To: City of Phoenix Planning Commission **Date:** February 4, 2026
From: Racelle Escolar, AICP
Principal Planner
Subject: ITEM NO. 14 (Z-SP-4-25-2) – APPROXIMATELY 400 FEET SOUTH OF THE SOUTHEAST CORNER OF THE 29TH AVENUE ALIGNMENT AND DOVE VALLEY ROAD

Rezoning Case No. Z-SP-4-25-2 is a request to rezone 4.17 acres located approximately 400 feet south of the southeast corner of the 29th Avenue alignment and Dove Valley Road from C-2 M-R NBCOD (Intermediate Commercial, Mid-Rise District, North Black Canyon Overlay District) to C-2 M-R SP NBCOD (Intermediate Commercial, Mid-Rise District, Special Permit, North Black Canyon Overlay District) to allow a self-service storage facility and household moving center (truck/trailer sharing, associated retail), and all underlying C-2 uses.

Illustrative Landscape Plan

L-1.01
01.13.2026

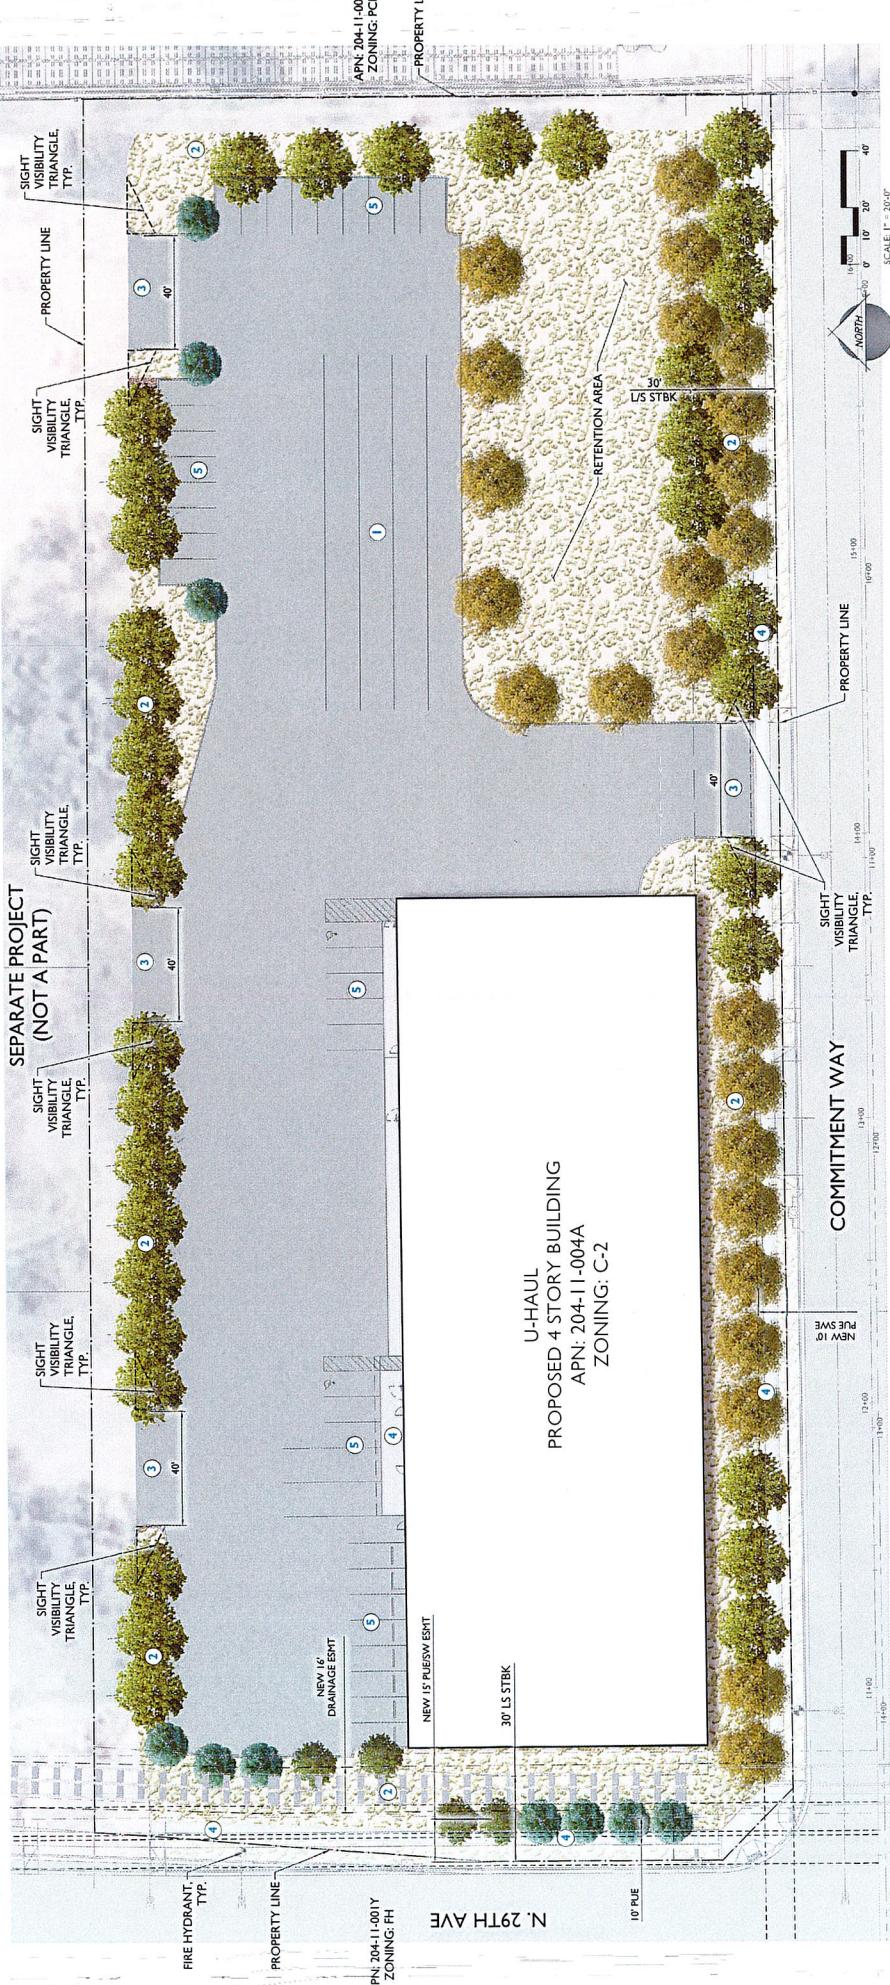
On January 14, 2026 the applicant submitted a revised landscape plan and requested a modification to Stipulation No. 5 to update the date stamped date for the landscape plan. The landscape plan was updated to include a second row of trees adjacent to the retention area along Woodstock Road. Additionally, the applicant requested modifications to Stipulation Nos. 6 and 7 regarding minimum building frontage to accurately reflect the proposal.

5. Retention areas and perimeter landscape areas, as depicted on the landscape plan date stamped ~~November 20~~ **DECEMBER 22, 2025 JANUARY 14, 2026**, shall be landscaped with minimum 2-inch caliper, single-trunk, large canopy, shade trees, planted 20 feet on center, or in equivalent groupings, planted in landscape areas, and planted around the perimeter of retention areas, and a minimum of five 5-gallon shrubs per tree and a mixture of shrubs, accents, and vegetative groundcovers, evenly distributed throughout the landscape areas to achieve a minimum of 50% live coverage, as approved by the Planning and Development Department.
